RECALL CAMPAIGN

REF. NO. 35
ENGINE GROUND STRAP

360 MODENA
360 SPIDER

RECALL CAMPAIGN NO. 35
360 MODENA / SPIDER
“ENGINE GROUND STRAP”
Technical Instructions

Replacement of the Engine Ground Strap:

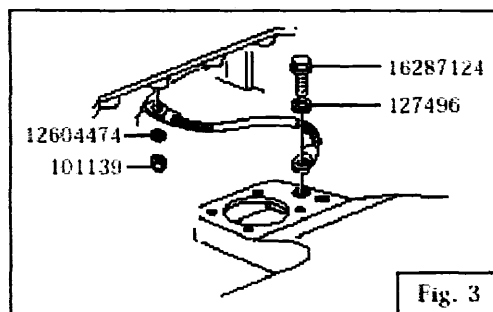
- Remove the underbody-fairing panel.
- Visually verify the engine ground strap connector crimping type (both ends).
- The **INCORRECT CRIMPING** of the ground strap connector is easily recognizable by the presence of a “**PLUS**” sign stamped on the connector. If one or both of the connectors have the presence of the stamping shown in **Fig. 1** (below), it is necessary to replace the engine ground strap with the new type shown in **Fig. 2** (below).
- If the engine ground strap has the correct type crimping (**Fig. 2** below), apply a dab of “red paint” to the ground strap mounting points to identify the updating.
- Replace the underbody-fairing panel, the recall is complete.

- Before replacing the ground strap (part number **155073**) clean the area of the contact surface of the terminal.
- Replace the split washer (part number **127496**), and the screw (part number **16287124**) mounting to ground strap to the chassis and tighten to a torque to **15Nm**.
- Replace the wave washer (part number **12604474**) and the self-locking nut (part number **101139**) mounting the ground strap to the sump of the motor and tighten to a torque of **20Nm**.
- Apply a dab of “red paint” to the ground strap mounting points to identify the updating.
- Replace the underbody-fairing panel.
